Groundwater Transfer Review Summary Form

Transfer/PA # T- 14607

Application: T-14607

Applicant Name: Rojas Nursery c/o Ildefonso Rojas

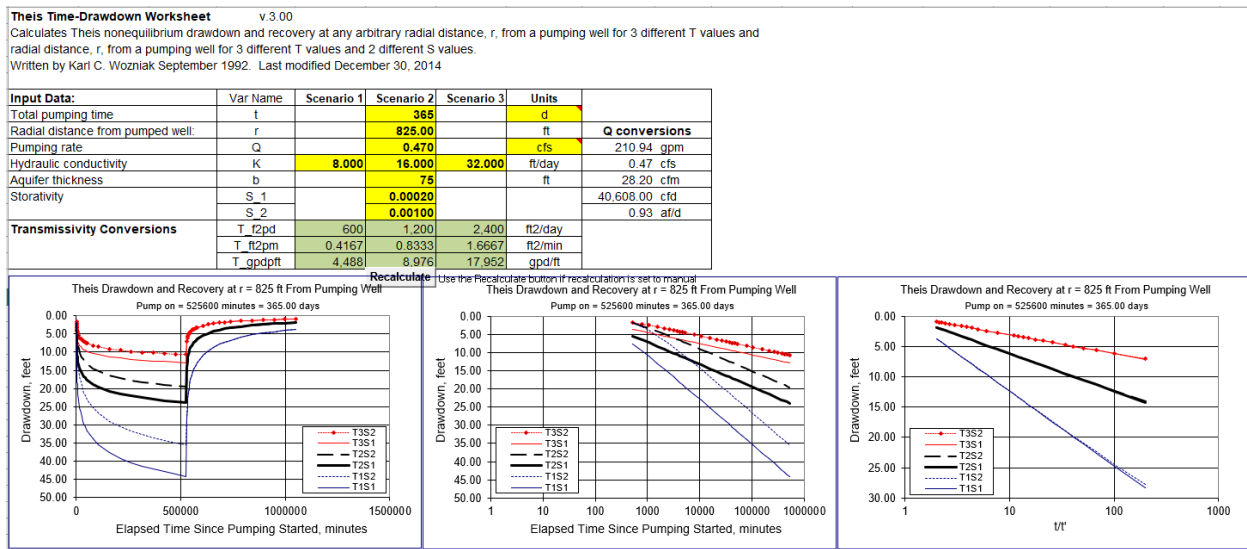
☐ Yes ☒ No If yes, explain: The potential interference between Proposed Well 2 and MULT 67824 was evaluated with the maximum authorized rate of 210 gpm. The results are shown on the attached figures.

Under more conservative aquifer parameters, drawdown may temporarily exceed 25 feet, particularly during irrigation season pumping; however, under all aquifer parameter scenarios evaluated, the total drawdown equilibrates to less than 25 feet. Therefore, the proposed change is unlikely to result in another groundwater right not receiving the water to which it is legally entitled.
